GWINNETT COUNTY
DEPARTMENT OF FINANCIAL SERVICES
PURCHASING DIVISION

ADDENDUM #3
BL074-22, F. Wayne Hill Water Resources Center Fire Alarm Monitoring System Improvements

BLOWER BUILDING NO. 1
ELECTRICAL ROOM
FLOOR PLAN - EXISTING

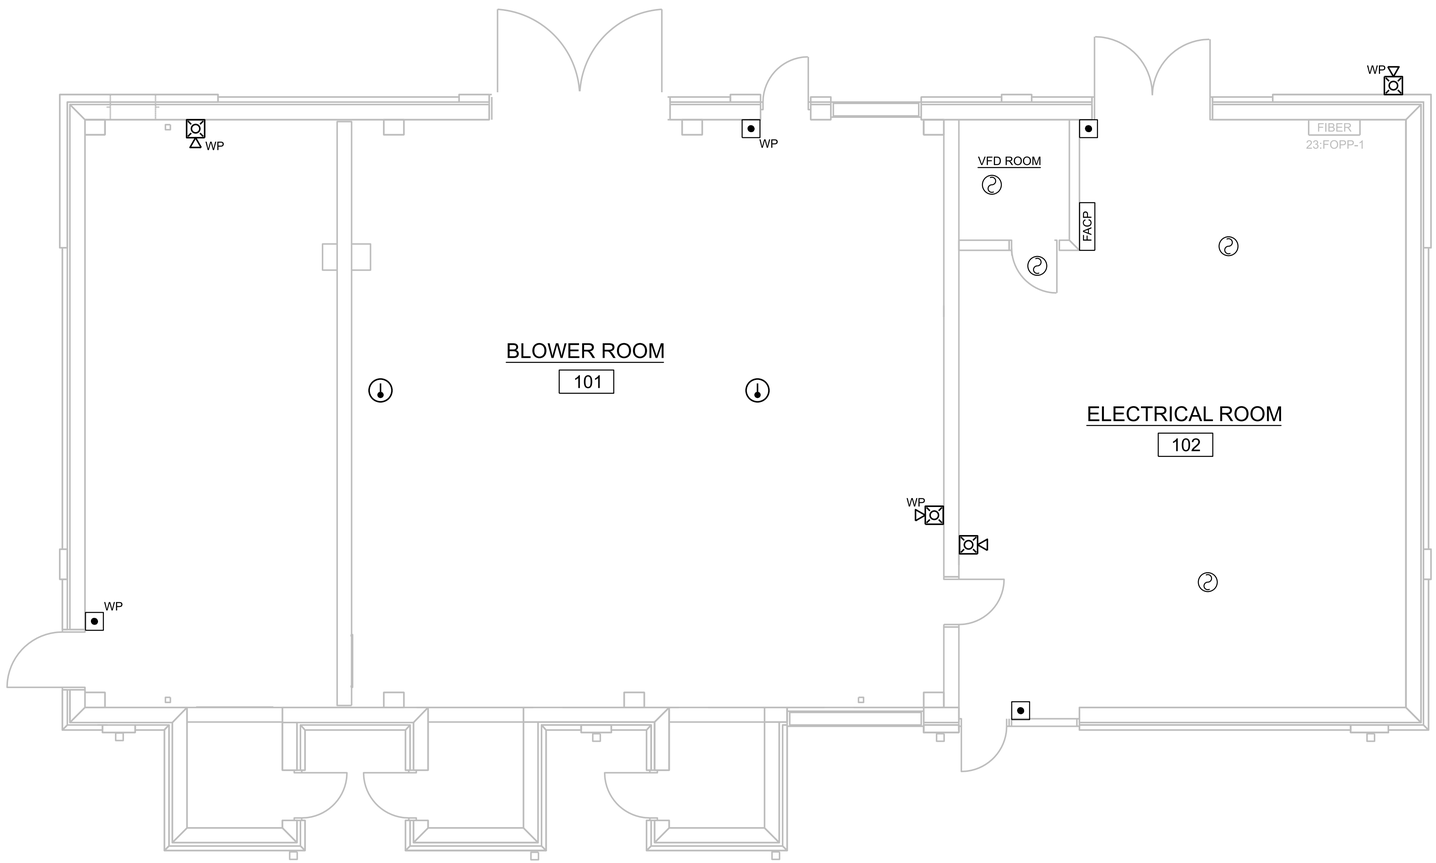
Q2. In reviewing the drawings, we could not locate existing drawing "232A-FA-2001 Lower Building #1 Existing Floor Plan" that is listed in the table of contents (FA-0000A Drawing Index) but not provided for download.

A2. 232A-FA-2001 Blower Building No.1 Electrical Room Existing Floor Plan is attached
